SUBJECT: Electric Gear Actuator and 950162 Bracket

SERVICE BULLETIN KIT NO. 20-131B

FIGURE 1
SERVICE BULLETIN M20-131B

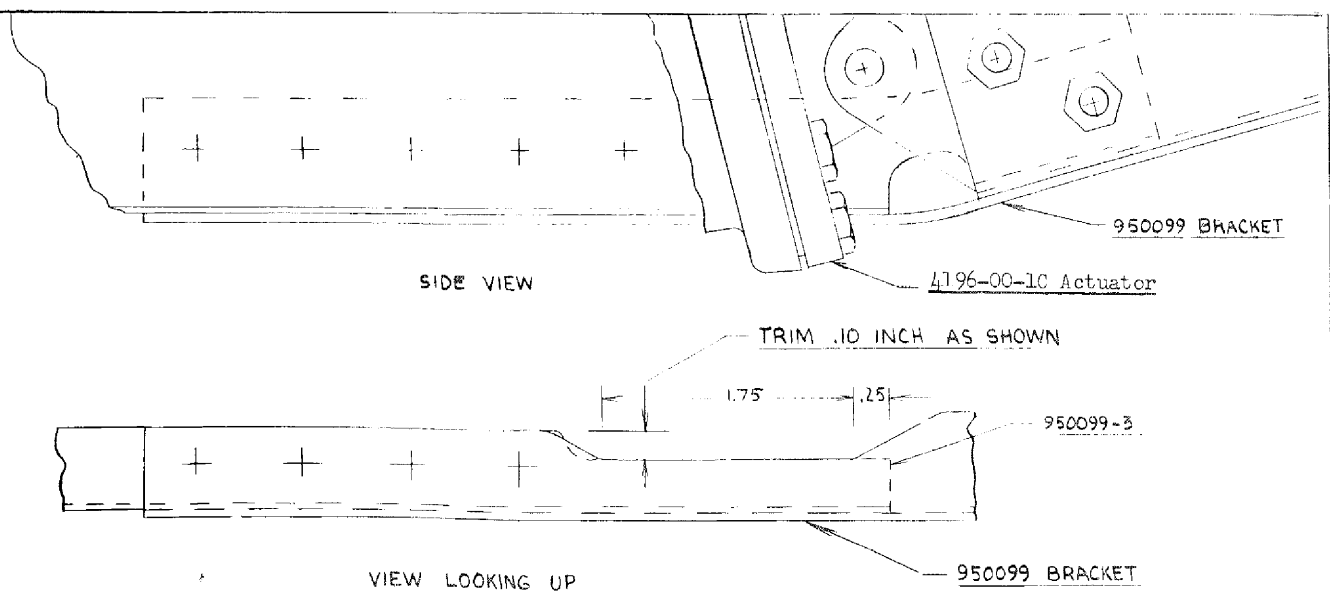
INTRODUCTION: All Dukes actuators P/N 4196-00-1A must be replaced within the next 15 hours of service after the effective date of this bulletin with Dukes actuators P/N 4196-00-1C. Upon installation of the Dukes actuator P/N 4196-00-1C, install Mooney bracket 950162 on the forward end of the actuator motor.

1. Place aircraft on jacks.
2. Remove 310124-501 access panel.
3. Remove present actuator and install 4196-00-1C actuator per Mooney drawing 950090.
4. It will also be necessary to file 950099 bracket in the vicinity of the actuator ball screw gear housing to provide a clearance fit. Zinc chromate after filing if necessary. See attached sketch.
5. Install 950162 bracket on forward edge of actuator motor per Mooney drawing 950090 (if not installed).
6. Attach 950132-1 cable assembly to 950162 bracket per Mooney drawing 950090.
7. Rig gear per 950090 gear installation drawing. Also, these instructions may be found in the latest issue of the M20C, D and E Service and Maintenance Manual. Review all applicable Service Bulletins and Instructions for compliance.
